Amendments To The Drawings

REMARKS/ARGUMENTS

Fig. 1

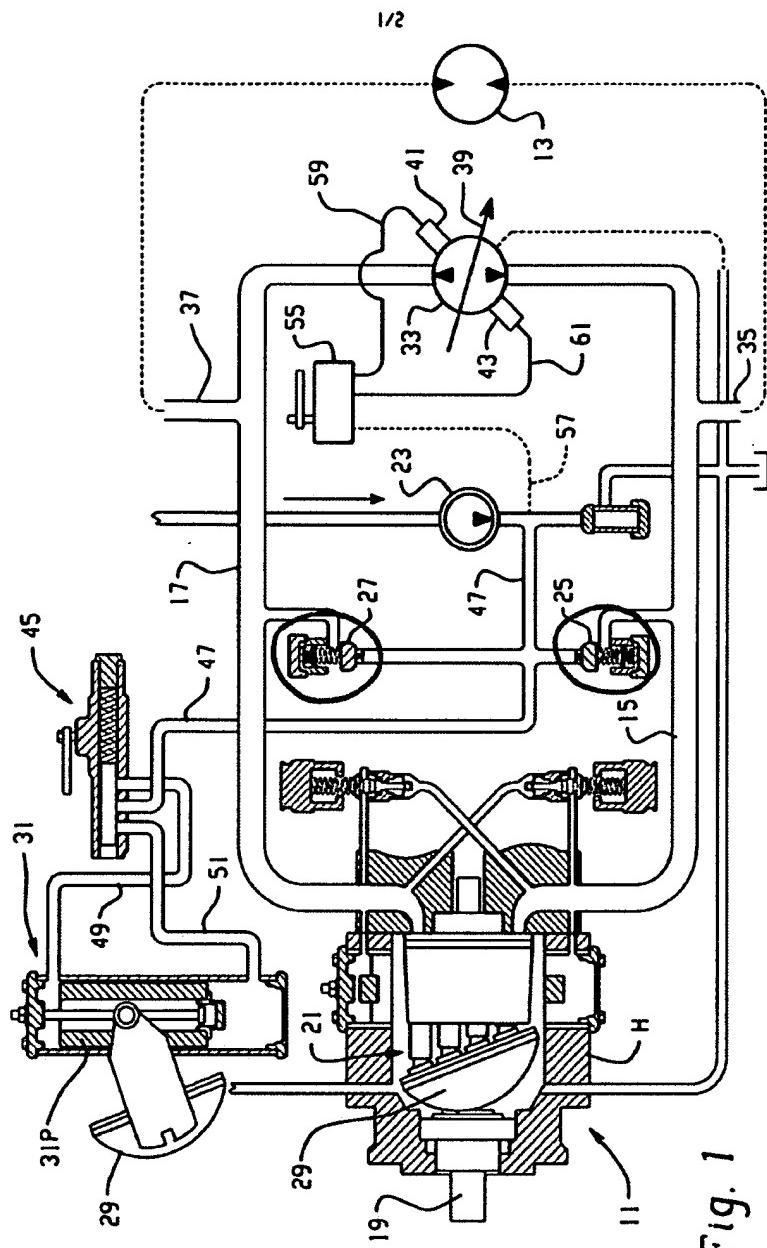
The attached sheet of drawings includes changes to FIG. 1. This sheet replaces the original sheet FIG. 1.

The Examiner has rejected claim 5 under 35 U.S.C. § 112, first paragraph, stating that "one is not enabled as to how the single relief valve assembly can communicate pressurized fluid from the fluid outlet port to the fluid inlet port." Although Applicant respectfully disagrees with the Examiner's assertion that one skilled in the art would not be enabled "as to how the single relief valve assembly can communicate pressurized fluid from the fluid outlet port to the fluid inlet port" for the reasons stated below, Applicant has amended the schematic representation of the relief valves 25 and 27 in FIG. 1 to better illustrate that which is described in paragraph 36 of Applicant's application. Specifically, the schematic representation has been amended to include a center section of the "head" of the relief valve 25 and 27 that will open when the pressure in conduit 15 and 17, respectively, increases beyond a predetermined point.
